MIDLAND UNITS 1 & 2
JOB NO. 7220

REVIEW OF U.S. TESTING
FIELD AND LABORATORY CONSTRUCTION
TEST DATA ON SOILS USED AS FILL

PREPARED BY
BECHTEL POWER CORPORATION
JUNE 12, 1979

FIGURE 10

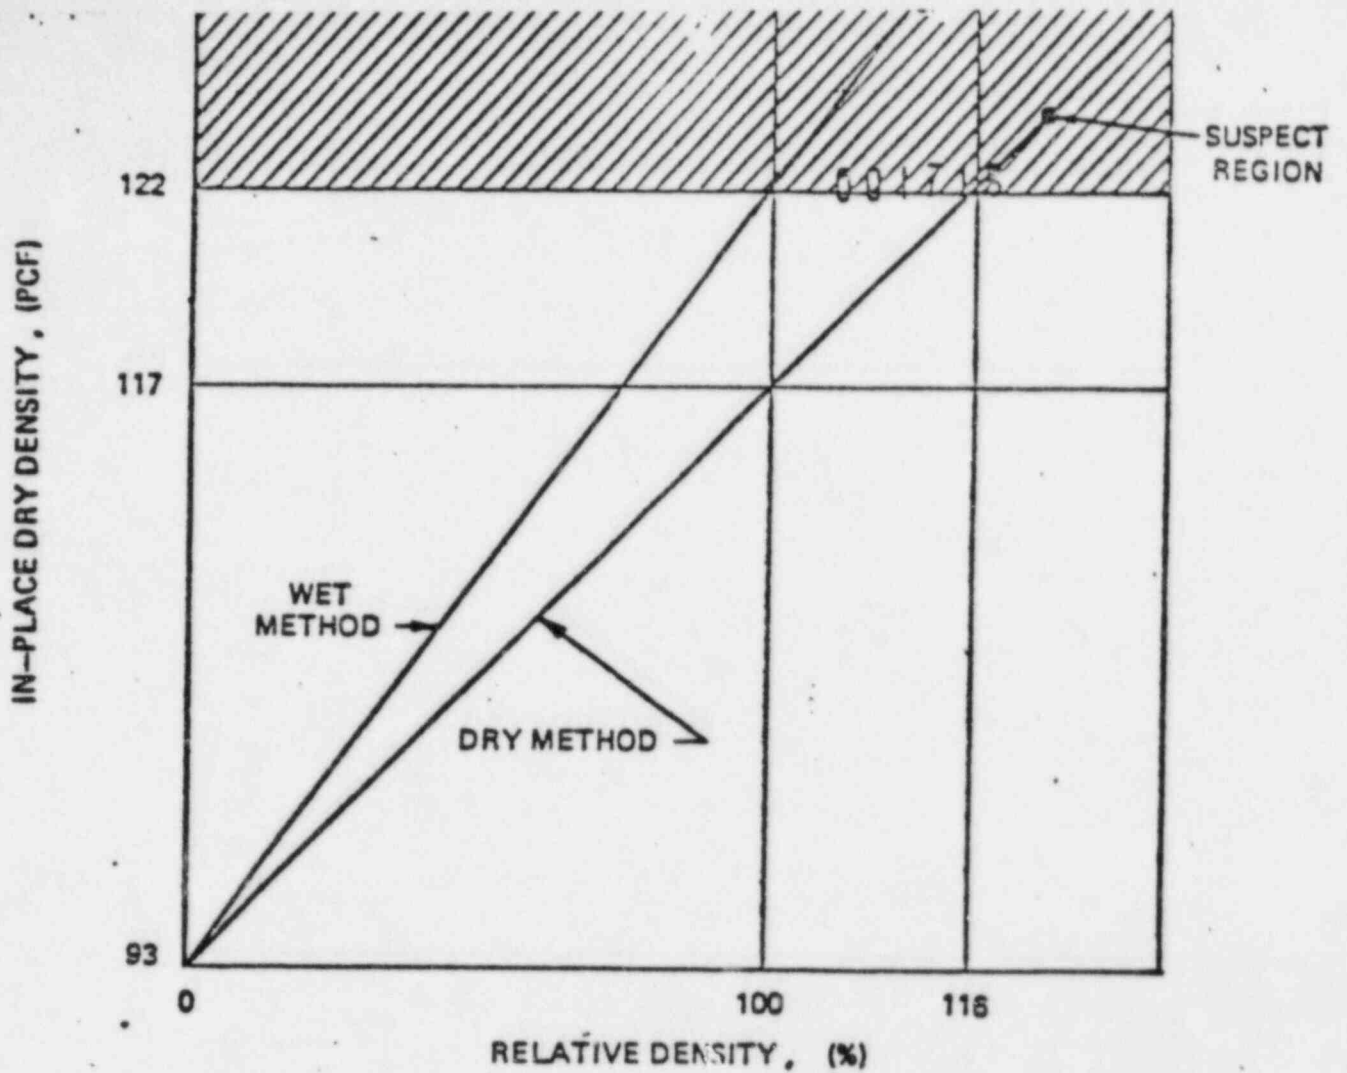
NOTE: VALUES FOR DRY DENSITY ARE TYPICAL OF A RANDOM FILL SAND. ANY TESTS SHOWING MORE THAN 117% RELATIVE DENSITY WOULD BE SUSPECT IN THIS EXAMPLE. STRUCTURAL SANDS TEND TO SHOW ONLY 2 OR 3 PCF INCREASE IN MAXIMUM DENSITY AND THUS RESULTS AT MUCH LOWER RELATIVE DENSITY WOULD BE SUSPECT, SAY 105 - 110 PERCENT

FIGURE 1

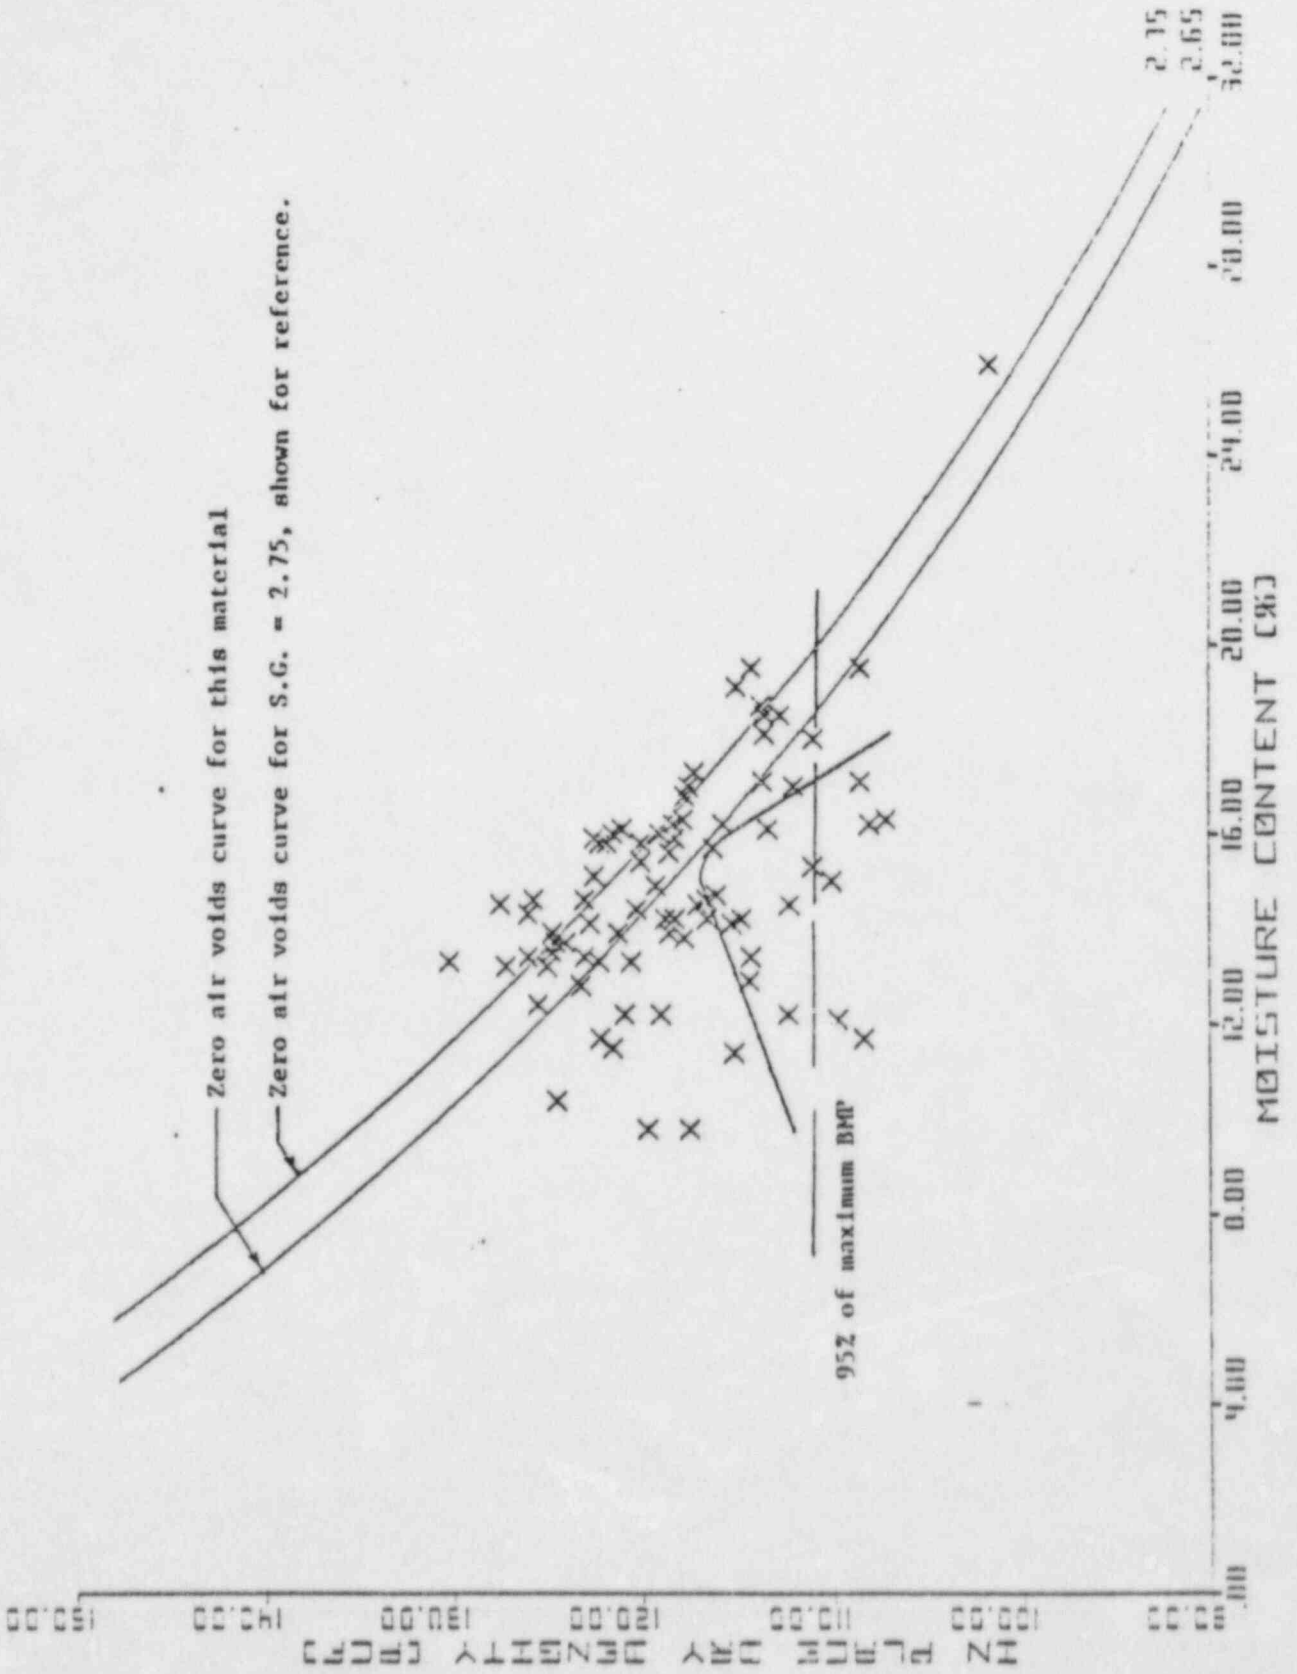
Also, referring to Figure 1 it would appear that soil density varied widely. Specifications called for compactive effort results as defined by ASTM D 1557 which is 56,255 ft-lb/ft³ energy. This was modified to a laboratory test compactive effort of about 20,000 ft-lbs/ft³ energy, often referred to as Bechtel Modified Proctor (BMP). Laboratory compaction test curves should be related to the same effort as that called for in the field for use in comparing with field density tests. According to plots of field data shown on Figure 1, density varied from about 108 lbs/ft³ to about 130 lbs/ft³. It is doubtful that the soil classification or other properties would be similar for such a wide variation in density. It is noted that 100 percent of modified Proctor (ASTM D 1557) which is difficult to obtain, is rated at 56,255 ft-lbs/ft³ energy. The curve plotted on Figure 1 is at about 20,000 ft-lbs/ft³ energy. For comparative purposes it was determined by U. S. Testing in 1974 that 100 percent of specified effort (20,000 ft-lbs/ft³) is approximately equal to 95 percent of the maximum density as determined by ASTM D 1557 (56,255 ft-lbs/ft³) Reference Figure 8. This means that a density up to 5 percent greater (dry density of 123.2 lbs/ft³) than that specified (dry density of 117.0 lbs/ft³) could be possible. However, some points shown on Figure 1 give an apparent density up to 11 percent above that specified.

FIGURE 7: WINDOWS OF ACCEPTABILITY (A) BASED ON BMP SPECIFICATION (B) REGARDLESS OF EXACT WORDING OF SPECIFICATION

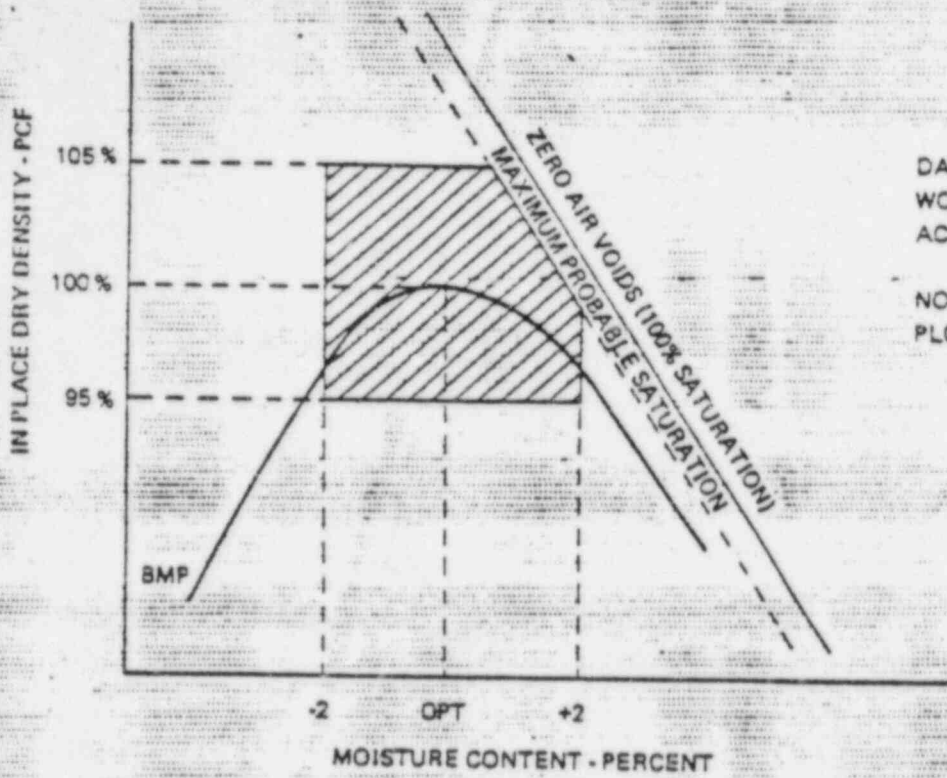
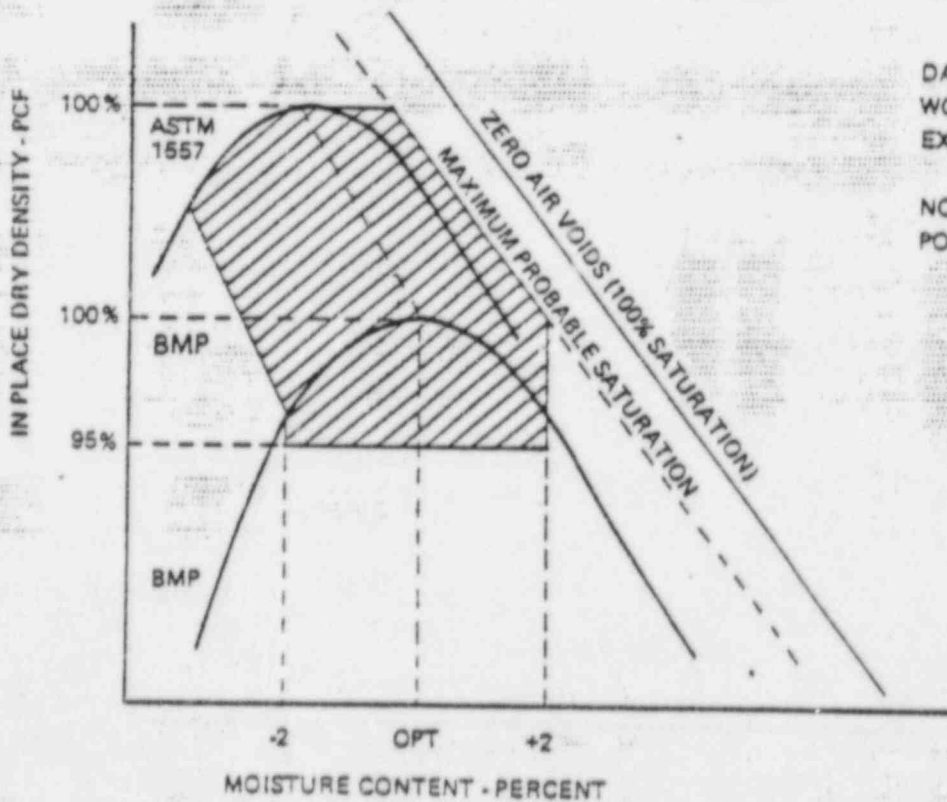
For a field test result to be valid as well as "Passing" it must fall within a well defined area on the plot containing the laboratory compaction curve. This area or window of acceptability is shown for a hypothetical compaction curve on Figure 7a that would meet requirements of Specification 7220-C-210. It is defined by horizontal lines at 95 percent and 105 percent of specified density, vertical lines through ± 2 percent of optimum moisture content, and a line parallel to the zero voids line indicating saturation about half way between the compaction curve and 100 percent saturation (zero air voids curve). The upper limit of 105 percent of specified density is not defined in the specifications. It was arbitrarily chosen as an upper limit since engineers knowledgeable in soil compaction have observed that numbers greater than this give increasingly invalid comparisons between field test results and the specified laboratory test curve. Therefore, if all data points fall within the defined window there would be no reason to assume that they are wrong. However, when many data points fall outside the designated area there is something wrong with the information and then all data points become suspect. A review of all data indicates that about 25 percent of the cohesive soil test results fall within this area.

Figure 7B shows an area where field test results would be acceptable, in theory even though not in strict accordance with the specifications. Figure 7B was arrived at by expanding Figure 7a to include test results up to a compactive effort related to ASTM D 1557 (56, 255 ft.-lbs/ft.³) which is considered to be a practical upper limit. About 40 percent of all cohesive soil test results would plot in this area.

DATA POINTS THAT PLOT IN SHADED AREA WOULD BE GENERALLY ACCEPTABLE ACCORDING TO SPECIFICATIONS

NOTE: ABOUT 25% OF ALL FIELD DATA PLOTS IN THE SHADED AREA

DATA POINTS THAT PLOT IN SHADED AREA WOULD BE ACCEPTABLE REGARDLESS OF EXACT SPECIFICATION WORDING

FIGURE 9

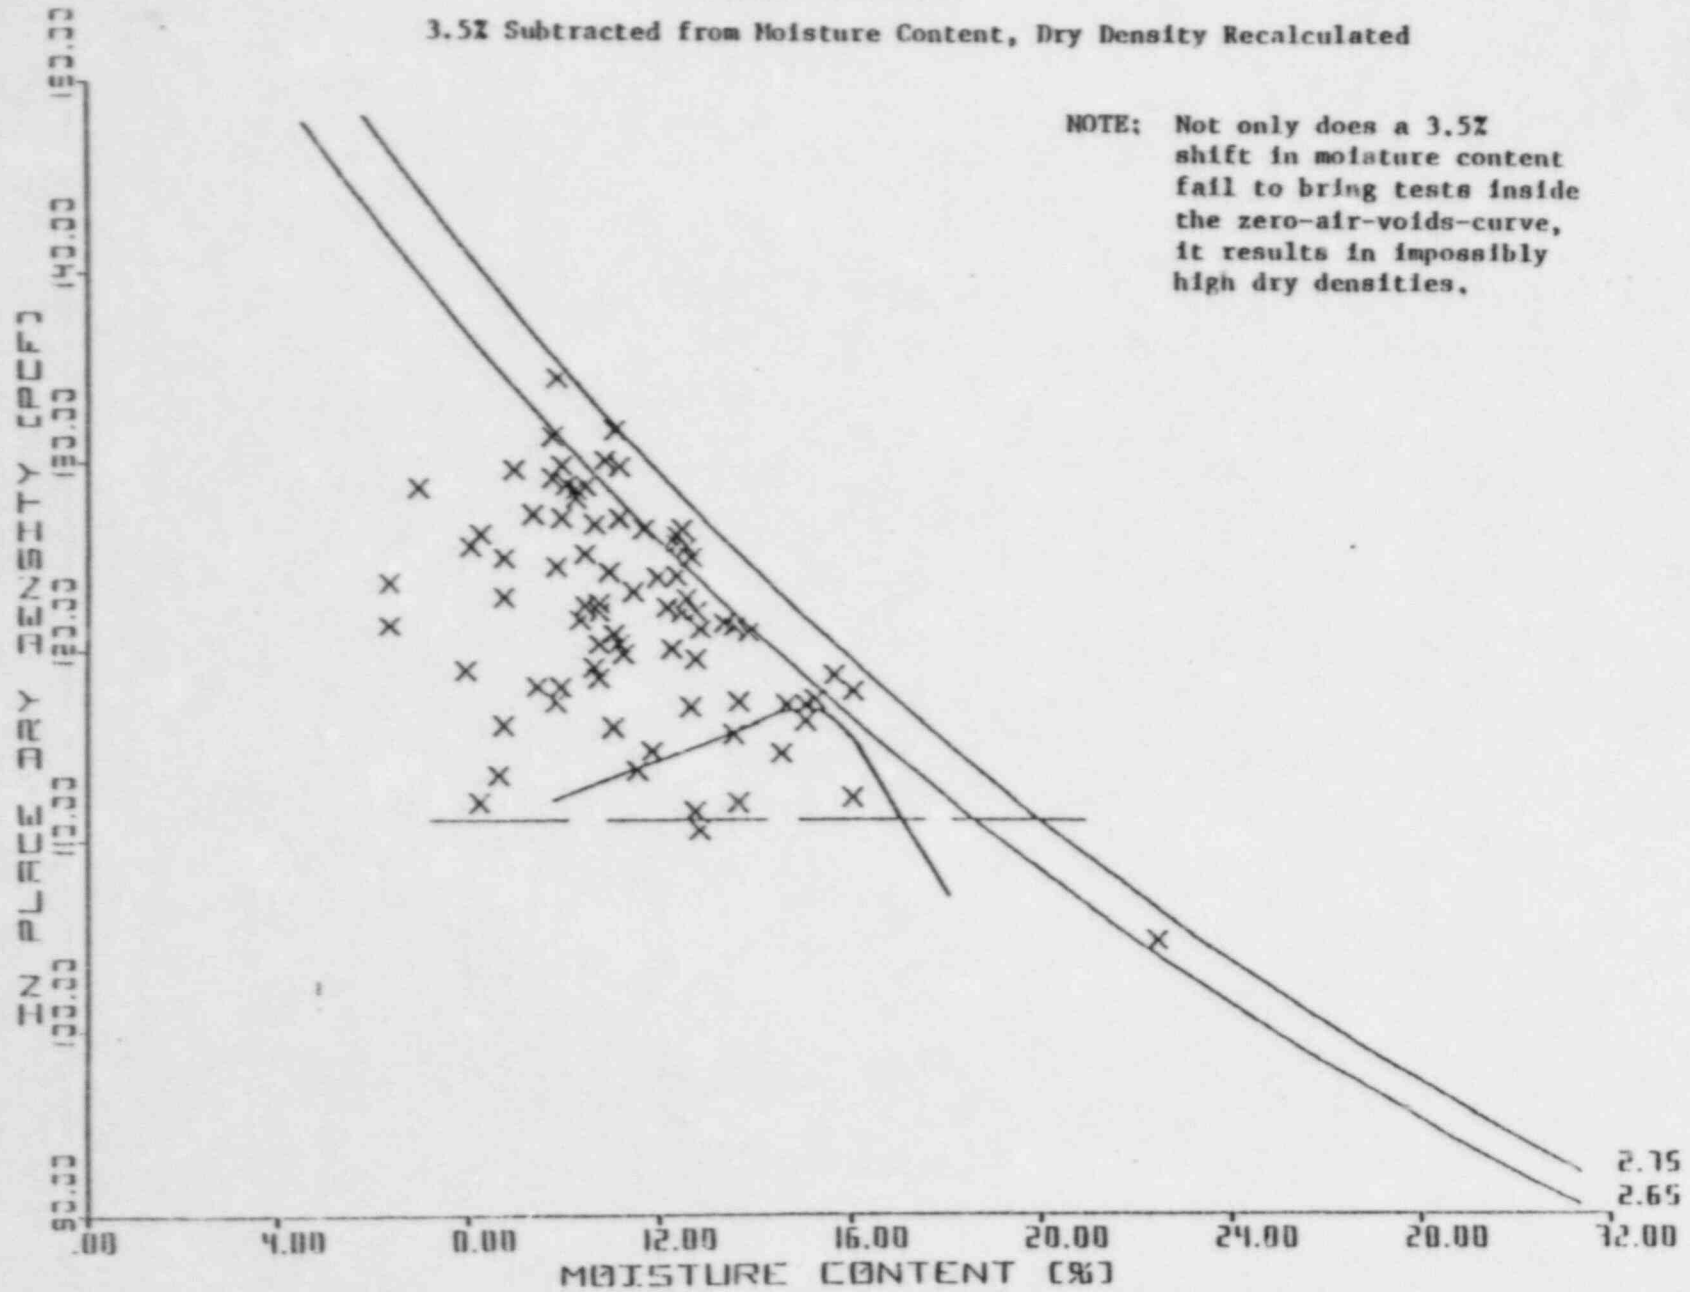
NOTE: Not only does a 3.5% shift in moisture content fail to bring tests inside the zero-air-voids-curve, it results in impossibly high dry densities.

FIGURE 10
 CHANGE IN RELATIVE DENSITY SCALE FROM DRY TO WET METHODS
 OF OBTAINING MAXIMUM DENSITY, BASED ON: RECENT LAB RESULTS

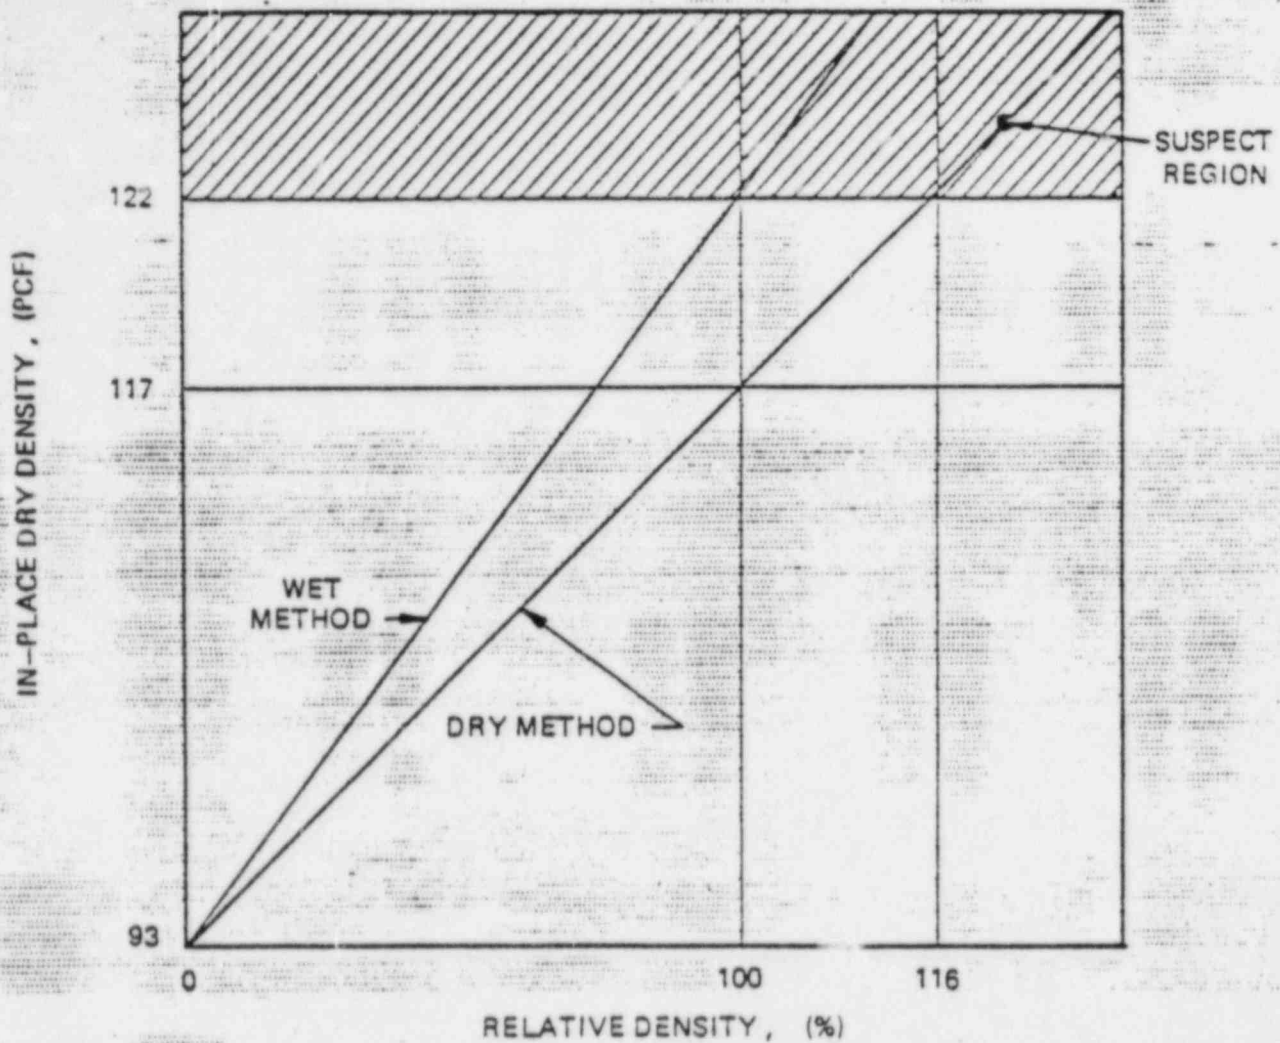
NOTE: VALUES FOR DRY DENSITY ARE TYPICAL OF A RANDOM FILL SAND. ANY TESTS SHOWING MORE THAN 117% RELATIVE DENSITY WOULD BE SUSPECT IN THIS EXAMPLE. STRUCTURAL SANDS TEND TO SHOW ONLY 2 OR 3 PCF INCREASE IN MAXIMUM DENSITY AND THUS RESULTS AT MUCH LOWER RELATIVE DENSITY WOULD BE SUSPECT, SAY 105 - 110 PERCENT
